DESIGN <i>PH</i>	DRAWN BY <i>PH</i>	<b>DART AEROSPACE LTD</b> HAWKESBURY, ONTARIO, CANADA	
CHECKED <i>PH</i>	APPROVED <i>PH</i>	DRAWING NO. DSI 9372	REV. A SHEET 1 OF 2
DATE 07.03.19		TITLE STAINLESS STEEL WEARSHOE KITS	SCALE NTS
A	07.03.19	NEW ISSUE

## **DART SERVICE INSTRUCTION**

**TO AMEND INSTALLATION INSTRUCTIONS D205-634 REV. D OR EARLIER AND  
INSTALLATION INSTRUCTIONS D204-635 REV. D OR EARLIER**

**FIGURE 1: DSI9372-011/-013 WEARSHOE KIT INSTALLATION**  
(D205-634-011 SKIDTUBE SHOWN, D204-635-011 SIMILIAR)

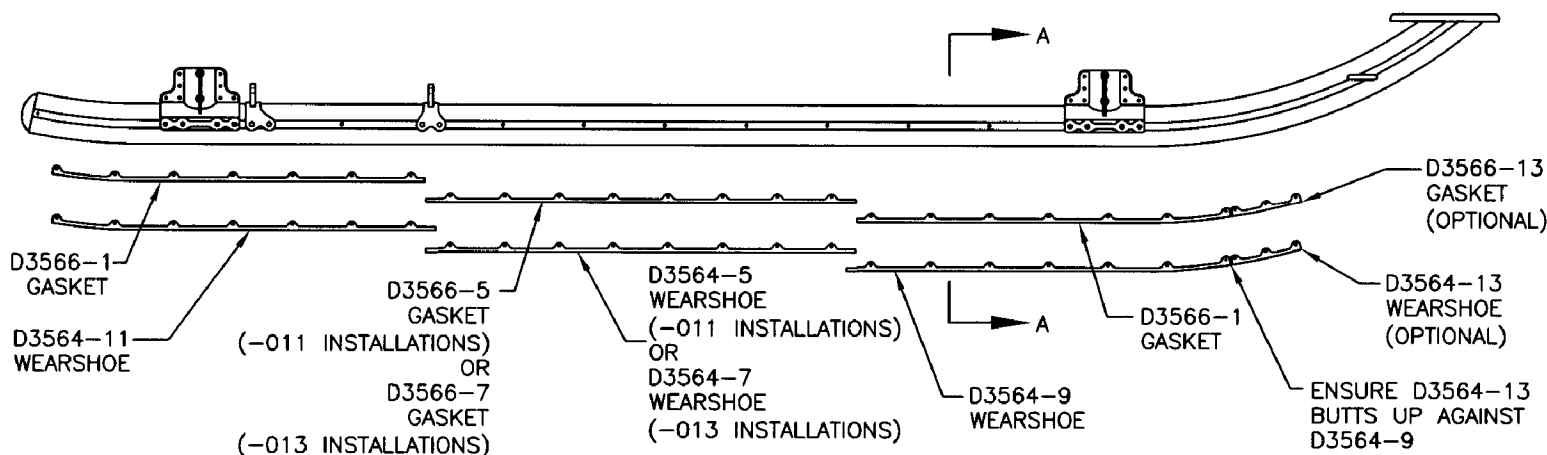
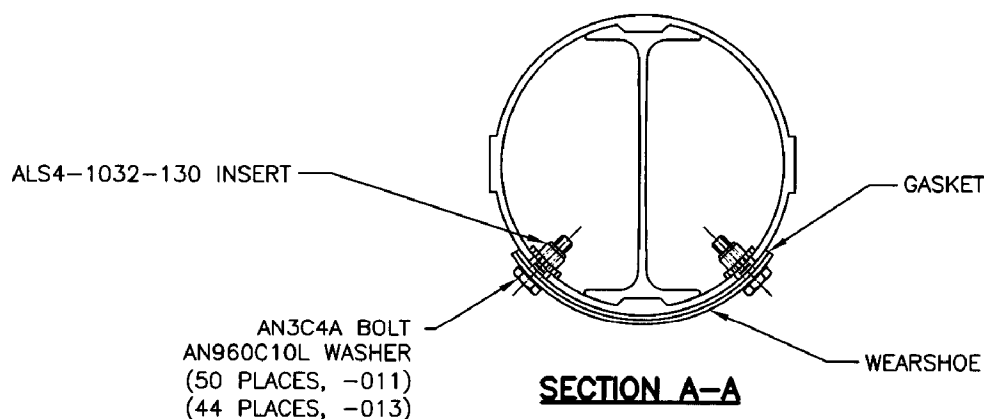
- 4) **Installation of D3564-13 Wearshoe and D3566-13 Gasket (optional)**  
Temporarily install the D3564-9 wearshoe complete with D3566-1 gasket at the fwd end of the skidtube as shown in Figure 1. Temporarily clamp the D3564-13 wearshoe and D3566-13 gasket ensuring that the wearshoe butts up against the D3564-9 wearshoe. Using the D3564-13 wearshoe as a template, drill  $\varnothing 0.125$  holes in the center of the wearshoe obounds (6 places). Remove wearshoes and open the  $\varnothing 0.125$  holes to  $\varnothing 0.297$ . Deburr. Touch up holes with chemical film material (Alodine 1200/1201) per MIL-C-5541 and one coat of MIL-P-85582 or MIL-P-23377 primer. Install ALS4-1032-130 inserts.

- 5) Install D3564-5/-7/-9/-11/-13 wearshoes complete with D3566-1/-5/-7/-13 gaskets using AN3C bolts beginning from the aft end of the skidtube and install towards the fwd end of the skidtube as shown in Figure 1. Seal all bolts with Sikaflex-241/-291 or Proseal 890 or MIL-S-8802 Class 'B2' sealant before installing. Torque bolts to 15-25 in-lbs (1.7-2.8 N-m).
